INFO-TECH CITROËN Racing C3R5 19-15**Sujet : Déverrouilleur BV (F90534161)**

Subject: Gearbox unlocking solenoid (F90534161)

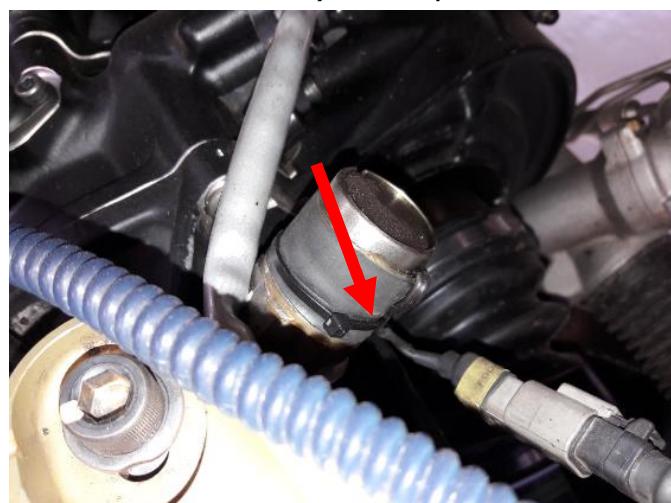
Afin de fiabiliser le fonctionnement du solénoïde de déverrouillage de boite de vitesses (pour éviter le grippage/oxydation de l'axe de déverrouillage suite à l'infiltration d'eau dans l'actionneur), nous vous recommandons de mettre de la CAF sur la partie AR de l'actionneur ainsi qu'autour du faisceau rentrant dans l'actionneur.

To increase the reliability of the unlocking solenoid (to avoid axle jamming/oxidation coming from water intrusion into the actuator), we advise you to place some silicone paste at the bottom of the solenoid as well as around the loom.

Merci de vérifier que le faisceau du déverrouilleur est bien maintenu autour de celui-ci par un rilsan.

Also ensure the solenoid loom is well secured by a tie rap.
